# Florida Department of Transportation

**MEMORANDUM NO. 04-04**

**SUBJECT: TAU-II CRASH CUSION SYSTEM  
FDOT QPL S544-0026 VENDOR DRAWING  
REQUIRED ADJUSTMENTS TO EXISTING TEMPORARY  
INSTALLATIONS**

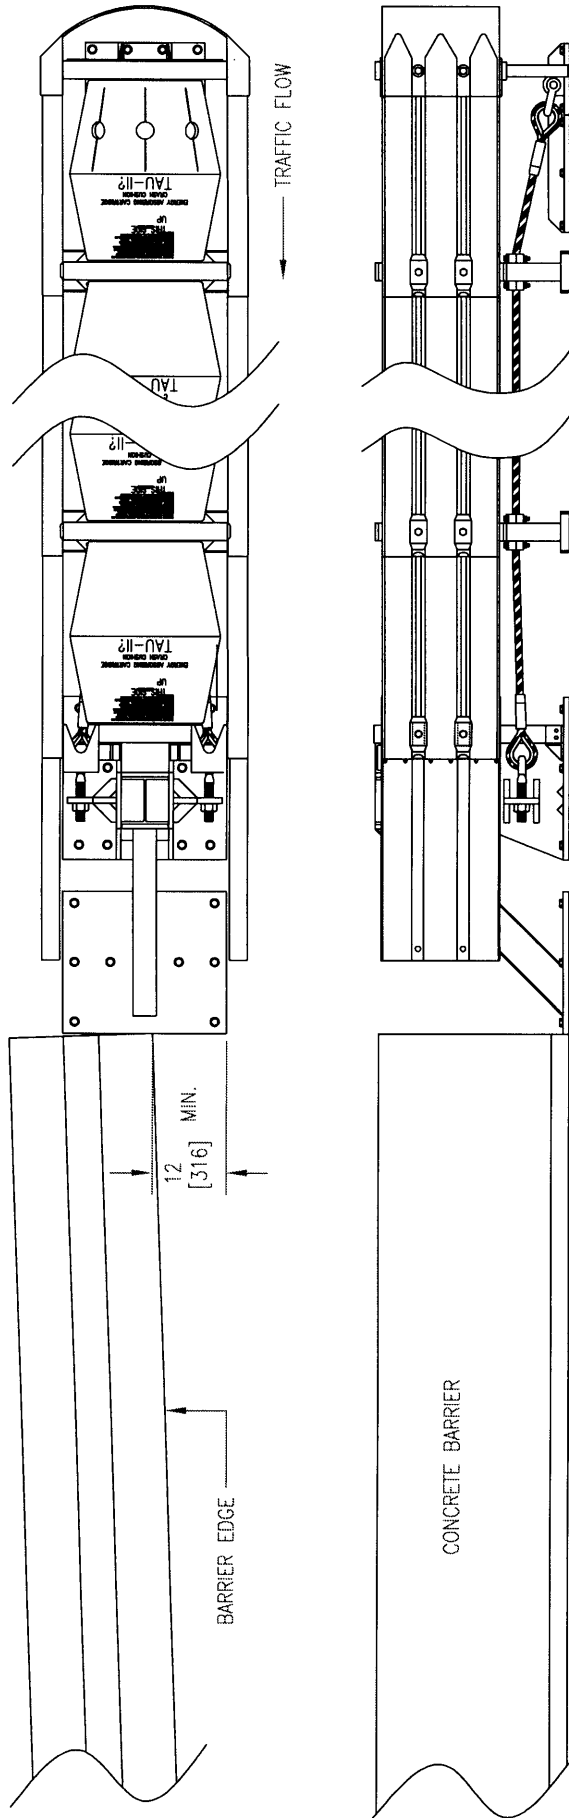
To address this, Barrier Systems, Inc. has provided two drawings that are attached to this memo. Drawing No. B040316-FL shows a relatively simple field adjustment that can be made on existing installations subject to unidirectional traffic on one side only. The adjustment consists of shifting the end of the temporary barrier wall away from the traffic side a minimum 12" from the traffic side edge of the Asphalt Backstop Assembly plate. This shift is necessary to provide adequate shielding of the barrier wall end for side impacts immediately upstream of the barrier wall end. Drawing No. B040316 is approved for use on projects currently under construction

subject to the following conditions:

1. The installation must be an existing temporary TAU II system using a Compact Backstop with the Asphalt Backstop Assembly on an asphalt foundation, installed prior to the date of this memo.
2. The installation is subject to unidirectional traffic on one side only.
3. There must be sufficient space to shift the barrier the required distance.

Drawing No. B040316 is not to be used for units installed after the date of this memo. Temporary Tau II units using a Compact Backstop with the Asphalt Backstop Assembly on an asphalt foundation installed after the date of this memo shall use only Drawing No. B040301 described below or subsequent approved drawings on the QPL.

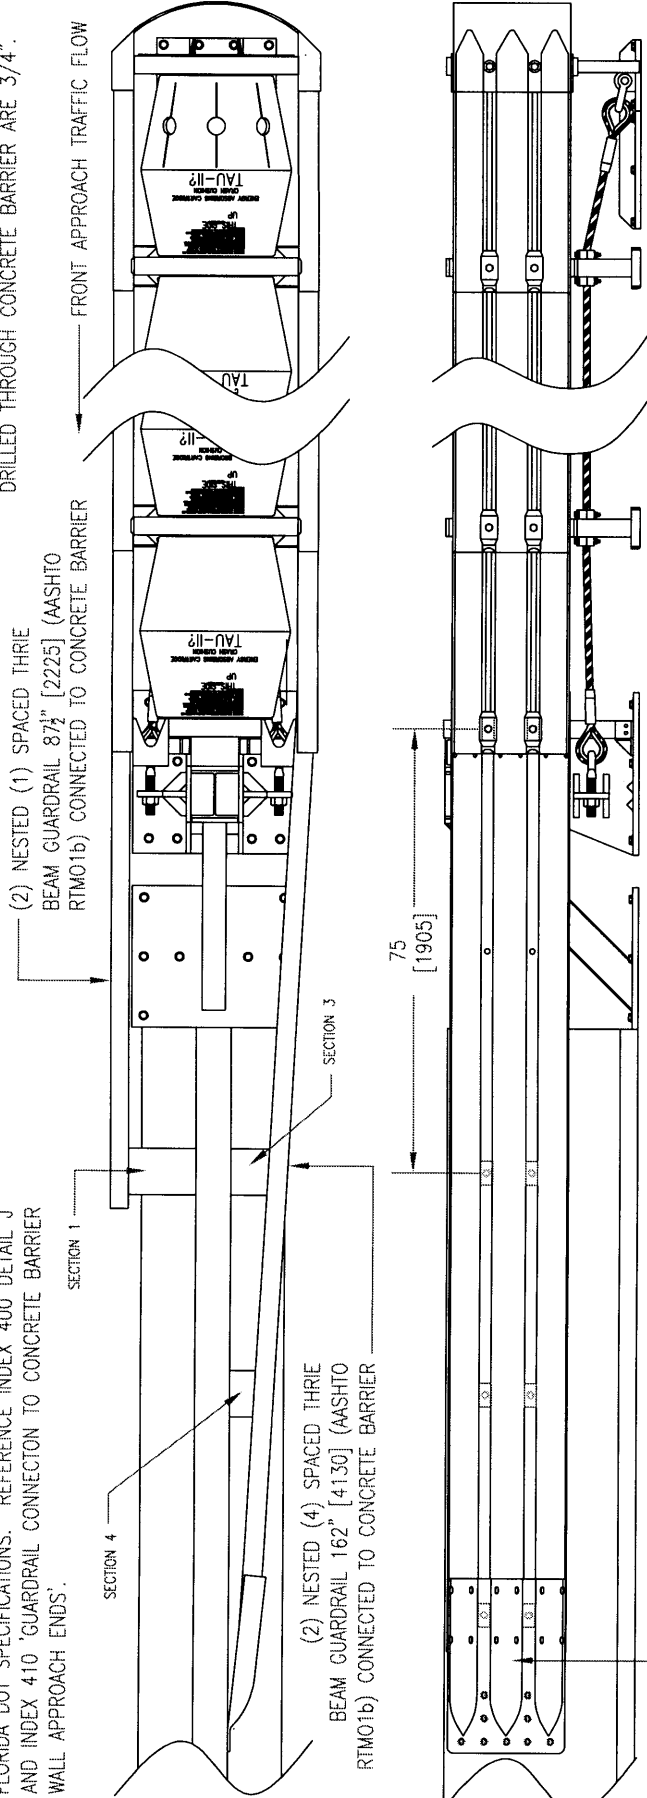
Drawing No. B040301 shows details for installing the TAU II system using the Compact Backstop with the Asphalt Backstop Assembly on an asphalt foundation to shield the end of a barrier wall. This drawing provides for thrie-beam extensions on the TAU II system that are connected to the barrier wall end unit being shielded. The details address unidirectional conditions as well as details for transition requirements for bi-direction or reverse direction hits. This drawing is approved for use when using the Compact Backstop with the Asphalt Backstop Assembly on an asphalt foundation. Existing installations using the Compact Backstop with the Asphalt Backstop Assembly on an asphalt foundation subject to traffic on both sides and/or reverse direction hits must be retrofitted in accordance with the details in this drawing. This drawing will soon be added to the QPL web site. Alternatively, the system can be reinstalled on an asphalt foundation using the PCB Backstop in accordance with QPL Drawing Number B020413 instead of using the Compact Backstop. Barrier Systems, Inc has submitted additional options for installation that are currently under review. These will be posted on the QPL web site when approved.
